ANN ARBOR HISTORIC DISTRICT COMMISSION

Staff Report

ADDRESS: 403 West Mosley, Application Number HDC17-044

APPLICATION: The applicant seeks HDC approval to replace two double-hung windows with casement windows to meet egress requirements in two bedrooms.

SIDEWALK / STREET VIEW

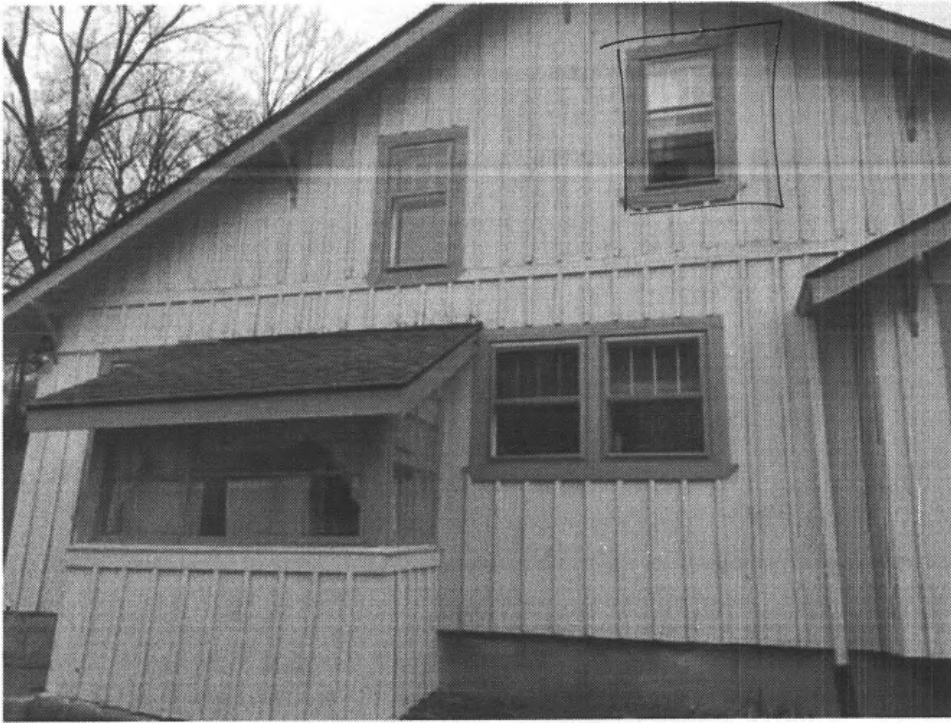
WINDOW CLOSEST TO
CHIMNEY TO BE
REPLACED

MARVIN BASEMENT WINDOW
IN 3 OVER 1 STYLE.
